RE:  
**ABYSS 08 2ND STAGE DEMAND LEVER (CODE: 46200777)**

**BTM19**

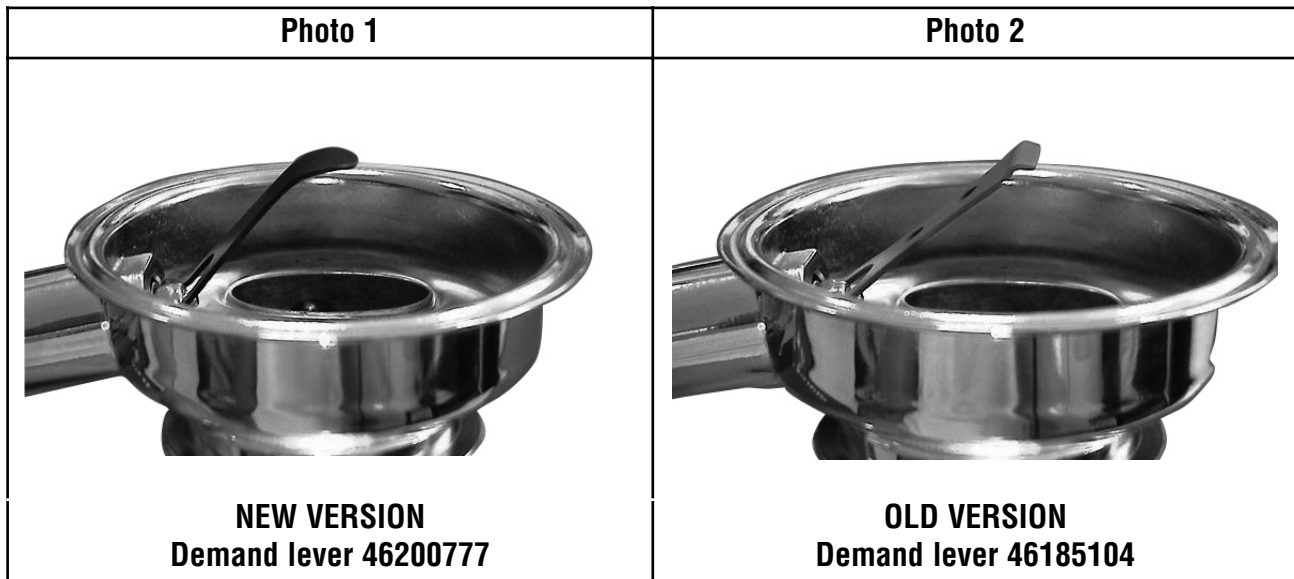
MARES TECHNICAL SUPPORT ANNOUNCES THAT BEGINNING WITH THE 2008 COLLECTION, ALL ABYSS 08 SECOND STAGES (ABYSS 42 CODE 416133; ABYSS 22 CODE 416134) WILL FEATURE STANDARD A NEW DEMAND LEVER WITH A DIFFERENT SHAPE THAN THAT USED IN THE PREVIOUS VERSION (PHOTO #1). THIS INNOVATION ENSURES BETTER PERFORMANCE FROM THE REGULATOR, PARTICULARLY AT DEPTHS OF GREATER THAN 35 M (115 F), ALLOWING FOR MORE NATURAL AND COMFORTABLE BREATHING IN ALL DIVING CONDITIONS. THE NEW DEMAND LEVEL (# 46200777) CAN BE USED IN VOLTREX/RUBY/ORBITER/ABYSS SECOND STAGES TO REPLACE THE PREVIOUS VERSION (CODE 46185104) (PHOTO #2).

TO DISASSEMBLE, REASSEMBLE, ADJUST, OR CHECK THE DEMAND LEVER 46200777 IN THE VOLTREX SECOND STAGE CASE 46186025, CONSULT THE CORRESPONDING MAINTENANCE MANUAL UNDER SECTION S 1-1 / S 1-6. IF THE MANUAL IS UNAVAILABLE PLEASE CONTACT MARES BEFORE PERFORMING ANY MAINTENANCE, ADJUSTMENT, OR CHECK PROCEDURE.
